Albert Bridge House, Manchester

Stage 1 Road Safety Audit Response Report

Curtins Ref: 080823-CUR-XX-XX-T-TP-00006
Revision: P01
Issue Date: 13 February 2023

Stage 1 Road Safety Audit

APPENDIX A: LOCATION PLAN

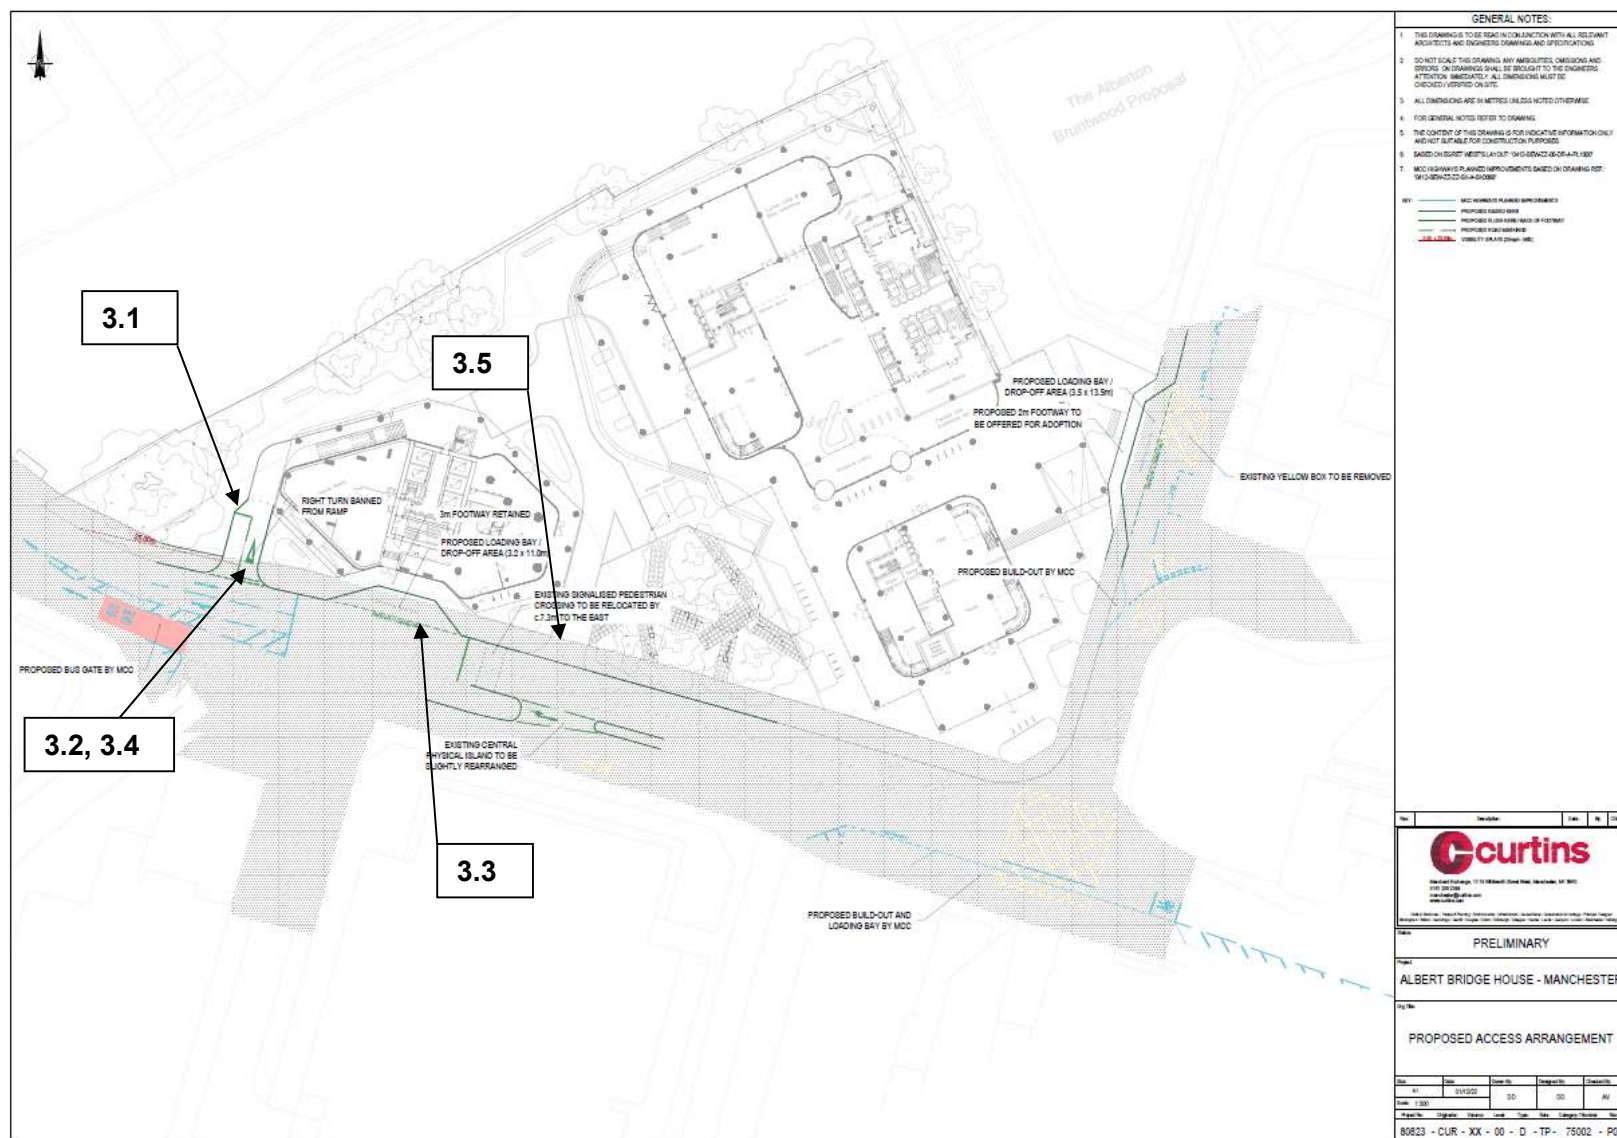
3.1 PROBLEM

LOCATION: Ramped entry to car park.

SUMMARY: Unclear whether storage capacity is adequate. Vehicles may overhang carriageway.

There appears to be signal control and a stop line for vehicles on the access ramp. Whilst the drawings state that the green light will be on default for ingress it is unclear whether there is sufficient storage space for more than one vehicle to enter and wait at the stop line should vehicles be exiting, or whether this scenario would emerge.

If this space is insufficient vehicles may overhang the carriageway of Bridge Street in possible conflict with through traffic. Waiting vehicles also may obscure the nearside traffic signal leading to possible junction conflicts, or pedestrians may cross between waiting vehicles, leading to possible conflicts with traffic exiting.

Investigate capacity of this area and examine how arrivals / departures will coincide. Ensure that there is sufficient storage space for anticipated vehicle numbers to wait upon entry to the car park when held up by vehicles exiting.

3.2 PROBLEM

LOCATION: Ramped access.

SUMMARY: Ramp may be difficult for vehicles to exit.

It is unclear the gradient of the ramped access to the development site, or whether there is a level dwell area in advance of the give-way line before vehicles enter Bridge Street. Should vehicles have to set off on a slope they may struggle to accelerate as anticipated or accept gaps in traffic safely. This could lead to emerging type conflicts.

Provide a level dwell area in advance of the give way line for vehicles to set off from.

3.3 PROBLEM

LOCATION: Bridge Street service layby.

SUMMARY: Visibility to traffic signals on exiting layby.

The signal-controlled crossing to the immediate east of the proposed service layby on Bridge Street is to be relocated. The traffic signal layout for this crossing is unclear. Whilst the stop line is shown, no signal heads are indicated. Should the driver of a vehicle exiting the bay not have visibility to a signal head they could fail to heed to pedestrians using the crossing.

Ensure that the location of signal heads are such that they can be seen clearly for vehicles exiting the service bay.

3.4 PROBLEM

LOCATION: Exit from development car park.

SUMMARY: Visibility to / awareness of signal heads may be poor.

The proposed egress from the development car park is located very close to the signal controlled junction of Bridge Street and Gartside Street. Drivers of vehicles exiting the development may have poor visibility to / awareness of signal heads at this junction due to their proximity, alignment and the fact that drivers may be concentrating on eastbound traffic approaching on Bridge Street. This could lead to drivers failing to heed the signals and conflicting with other vehicles within the junction or pedestrians using the crossing.

Ensure that visibility to / awareness of the signal heads for drivers approaching the give way line on the car park egress is maximised. This could include visibility over the land to the east of the egress being available. Also traffic signal heads should be aligned towards the egress, and located in positions that offer adequate visibility from the egress.

3.5 PROBLEM

LOCATION: Bridge Street upon exit from maintenance access route.

SUMMARY: Vehicles may turn right.

Vehicles leaving the maintenance route may try to turn right, either through the right turn access in the central reserve, or through the signal controlled junction against

opposing traffic. These movements would be unexpected and could lead to conflict with traffic generally.

Install left turn only signs for traffic leaving the maintenance route.

Ref.	Location	Summary	Recommendation	Design Team Response
Problem 3.1	Ramped entry to car park	Unclear whether storage capacity is adequate. Vehicles may overhang carriageway. There appears to be signal control and a stop line for vehicles on the access ramp. Whilst the drawings state that the green light will be on default for ingress it is unclear whether there is sufficient storage space for more than one vehicle to enter and wait at the stop line should vehicles be exiting, or whether this scenario would emerge. If this space is insufficient vehicles may overhang the carriageway of Bridge Street in possible conflict with through traffic. Waiting vehicles also may obscure the nearside traffic signal leading to possible junction conflicts, or pedestrians may cross between waiting vehicles, leading to possible conflicts with traffic exiting.	Investigate capacity of this area and examine how arrivals / departures will coincide. Ensure that there is sufficient storage space for anticipated vehicle numbers to wait upon entry to the car park when held up by vehicles exiting.	The storage space between the give way line and the back of footway (adopted highway) is c.10m. This is considered sufficient to accommodate two average cars. The car park can accommodate a total of 24 car parking spaces, of which 16 will be dedicated to office use. On this basis, access will be tidal. The storage space is therefore considered sufficient with space for two cars. This, combined with the reduced number of parking spaces, plus the nature of vehicular movements through the day and the fact that the signal will be on green by default for ingressing vehicles, suggest that the likelihood of vehicles queueing back onto the footway is extremely unlikely.

Problem 3.2	Ramped access	Ramp may be difficult for vehicles to exit. It is unclear the gradient of the ramped access to the development site, or whether there is a level dwell area in advance of the give-way line before vehicles enter Bridge Street. Should vehicles have to set off on a slope they may struggle to accelerate as anticipated or accept gaps in traffic safely. This could lead to emerging type conflicts.	Provide a level dwell area in advance of the give way line for vehicles to set off from.	The storage space before the traffic signal providing access to the basement will be flat, or provided with a very reduced incline (for drainage reasons). On this basis, egressing vehicles will have a relatively flat space to stop before joining the public highway. The ramp itself is provided with a level space, located approximately halfway the straight section.
Problem 3.3	Bridge Street service layby	Visibility to traffic signals on exiting layby. The signal-controlled crossing to the immediate east of the proposed service layby on Bridge Street is to be relocated. The traffic signal layout for this crossing is unclear. Whilst the stop line is shown, no signal heads are indicated. Should the driver of a vehicle exiting the bay not have visibility to a signal head they could fail to heed to pedestrians using the crossing.	Ensure that the location of signal heads are such that they can be seen clearly for vehicles exiting the service bay.	The recommendation is accepted. Location of the signal heads will be dealt with at the detailed design stage.

Ref.	Location	Summary	Recommendation	Design Team Response
Problem 3.4	Exit from development car park	Visibility to / awareness of signal heads may be poor. The proposed egress from the development car park is located very close to the signal controlled junction of Bridge Street and Gartside Street. Drivers of vehicles exiting the development may have poor visibility to / awareness of signal heads at this junction due to their proximity, alignment and the fact that drivers may be concentrating on eastbound traffic approaching on Bridge Street. This could lead to drivers failing to heed the signals and conflicting with other vehicles within the junction or pedestrians using the crossing.	Ensure that visibility to / awareness of the signal heads for drivers approaching the give way line on the car park egress is maximised. This could include visibility over the land to the east of the egress being available. Also traffic signal heads should be aligned towards the egress, and located in positions that offer adequate visibility from the egress.	The recommendation is accepted. Location of the signal heads will be dealt with at the detailed design stage.

Problem 3.5	Bridge Street upon exit from maintenance access route.	Vehicles may turn right. Vehicles leaving the maintenance route may try to turn right, either through the right turn access in the central reserve, or through the signal controlled junction against opposing traffic. These movements would be unexpected and could lead to conflict with traffic generally.	Install left turn only signs for traffic leaving the maintenance route.	The recommendation is accepted. Provision of vertical signage will be dealt with at the detailed design stage.
